Disability Access Report

Affordable Rental Housing
26 Russell Street
EAST GOSFORD NSW

For: Active Edge Constructions
Ref: LP_20148

Figure 2 | Overall Site Plan

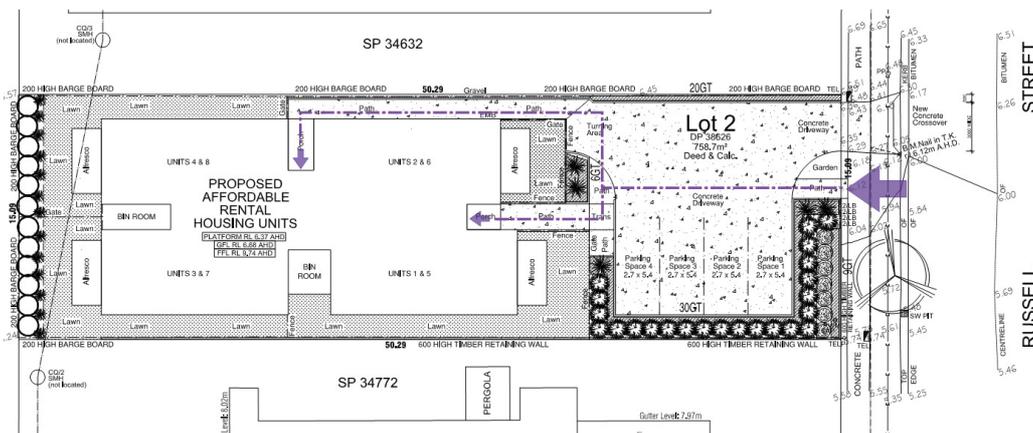
Landscape plan indicates that pedestrian areas are level, providing an accessible path of travel between Russell Street and the building entrance.

Landscape plan indicates that pedestrian areas are level. Pathway widths are in excess of 1500mm.

- a. The minimum unobstructed width of all pathways is to be 1000mm (AS1428.1, Clause 6.3). A width of 1200mm is preferred per AS1428.2.
- b. All pathways are to be constructed with no lip or step at joints between abutting surfaces (a construction tolerance of 3mm is allowable, or 5mm for bevelled edges).
- c. The maximum allowable crossfall of pathways is to be 1:40.
- d. The ground abutting the sides of the pathways should follow the grade of the pathway and extend horizontally for 600mm. We note that this is not required where there is a kerb or handrail provided to the side of the pathway.
